Docket Item #5
BAR CASE #2005-0256

BAR Meeting
February 1, 2005

ISSUE: Additions and Alterations

LOCATION: 519 South Lee Street

Figure 2 Proposed north elevation

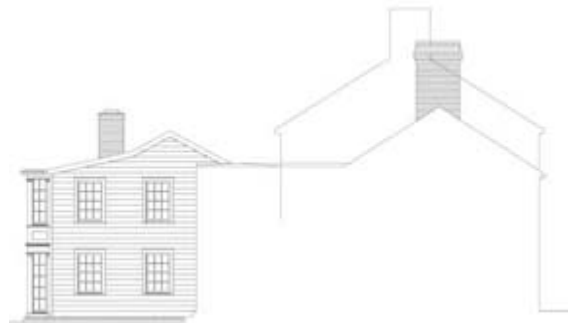
casing within inoperable shutters has been introduced on the addition's north elevation to give relief to the expanse of Hardi-plank siding.
